Accredited Standards Committee  
X3, Information Processing Systems

Doc: X3T10.1/95a225R2  
Date: February 2, 1996  
Project: X3T10.1/1147  
Ref. Doc.: SSA-TL2, 95a225R1  
Reply to: Rick Born

Subject: SSA Speed Negotiation

Figure 1. Speed negotiation algorithm.

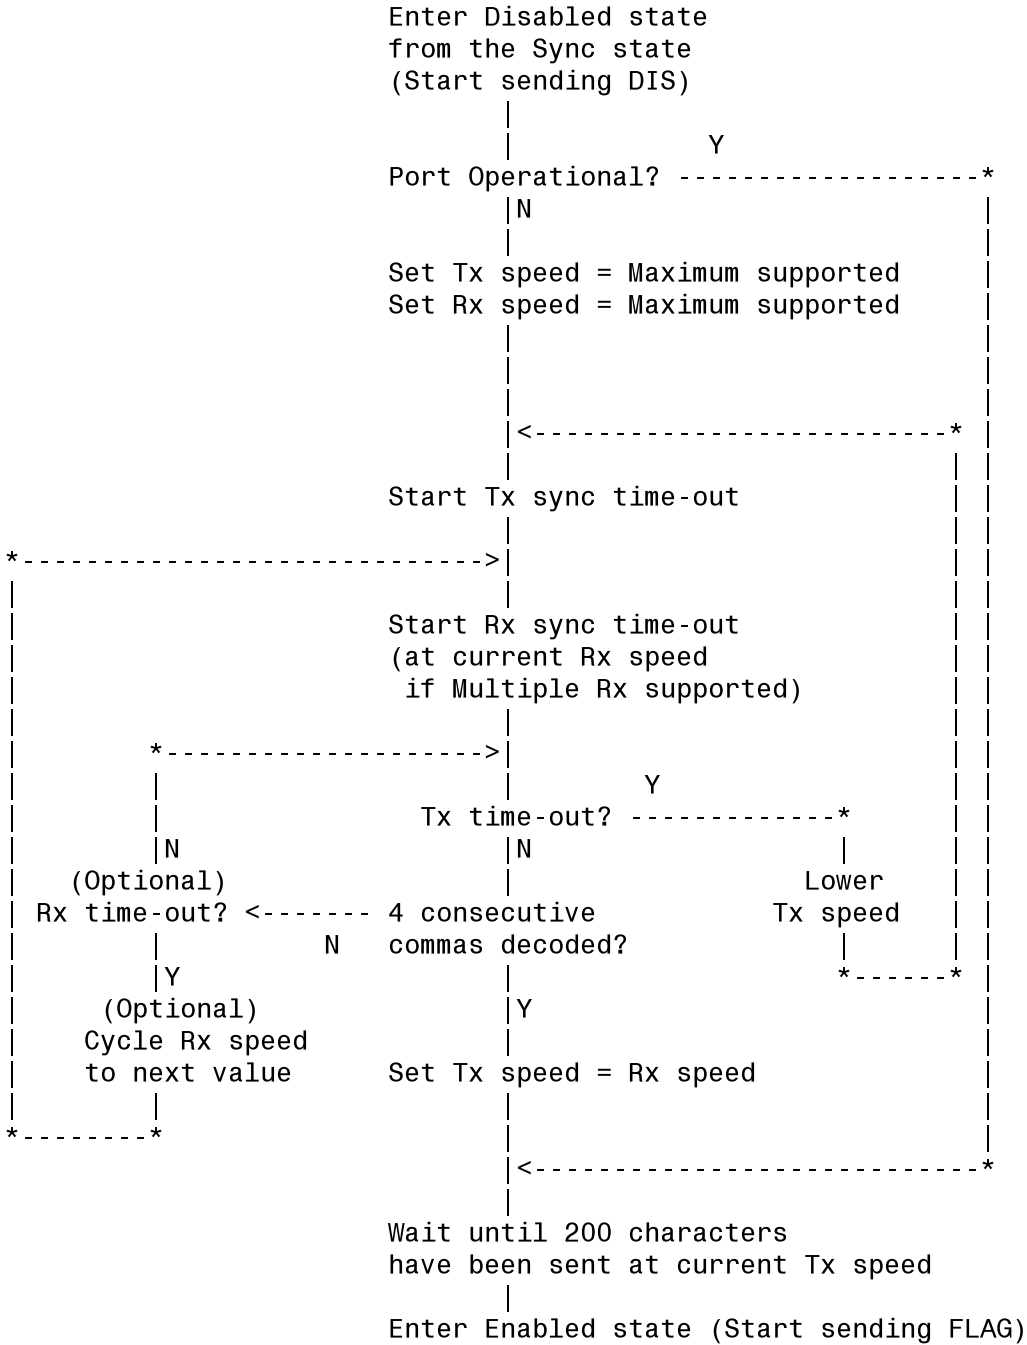
The link speed is negotiated automatically at power-on. This is essential to allow communication to be established, which is a pre-requisite for configuring or resetting the Web. This proposal will guarantee communication at the highest data rate in common between two nodes if the link is capable of supporting communication at the highest common speed. Each port performs the negotiation algorithm in Figure 1 during the Disabled state, but only if the port is not operational. Negotiation is performed at power-on and after an unrecoverable link error or Total/Absolute Reset; it is not performed for recoverable link errors. Each port must complete speed negotiation before entering the Ready state (otherwise an RR may be lost). If a transmitter timeout occurs before going to Ready state, the port shall return to Disabled state and continue with the speed negotiation. If character synchronization is lost during the Enabled state after an unsuccessful speed negotiation, the port shall go to the Sync state in order to begin the speed negotiation again. The operating speed is locked in the Enabled, Ready and Check states.

A simple and fast method of synchronization trial can be achieved if we vary the Tx sync time-out that a node will attempt synchronization based on its current speed. Standardize on a maximum time for 20MB/s SSA, and then reduce it by half for each higher speed step. Since the lower speed port will remain at that speed longer than the total sum of the dwell times at the higher speeds, the two will synchronize at the highest common speed. Table 1 illustrates this point.

Figure 2. State transitions

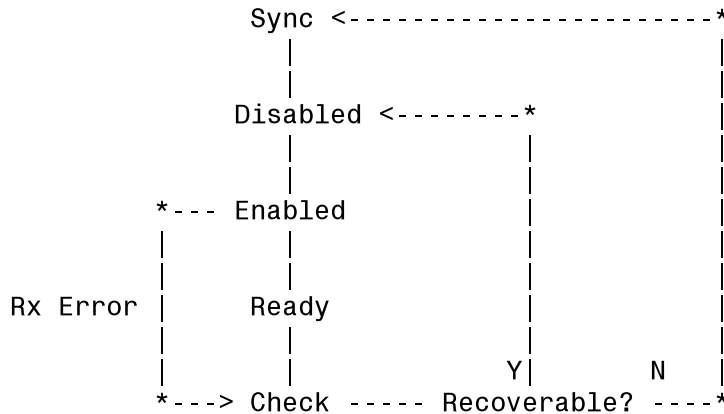
The above speed negotiation algorithm requires the two ports to become synchronized before beginning the speed negotiation. This requires the addition of the Sync state to the state transitions.

While in the Sync state, the outbound line sends a 10MHz signal for a minimum of 10us. When the port recognizes 10MHz on its inbound it then stops transmitting any signal on the outbound line for a minimum of 200ns (2 periods at 10MHz). Once it recognizes that the remote port has stopped transmitting the 10MHz signal, then the port transitions from the Sync state to the Disabled state and begins speed negotiation. If the port has been sending 10MHz for 100ms and not recognized 10MHz on its inbound line, it shall transition from the Sync state to the Disabled state and begin speed negotiation. (Note: this timeout is needed for communicating with present 20MB/s nodes and other single speed nodes that do not support speed negotiation and will not proceed through the Sync state on failed ERP or at Power-up). There is also currently a 25ms timeout defined in the Link ERP procedure and thus acts to justify the numbers chosen to begin in the table. Upon leaving the Sync state the port will be in Privileged mode and the Operational Flag shall be cleared.

Upon exiting the Check state, the speed negotiation is performed if the port is not Operational.

While in Enabled state, the port shall go to Disabled or Sync state if the receiver detects a loss of sync or 10MHz is detected, respectively.
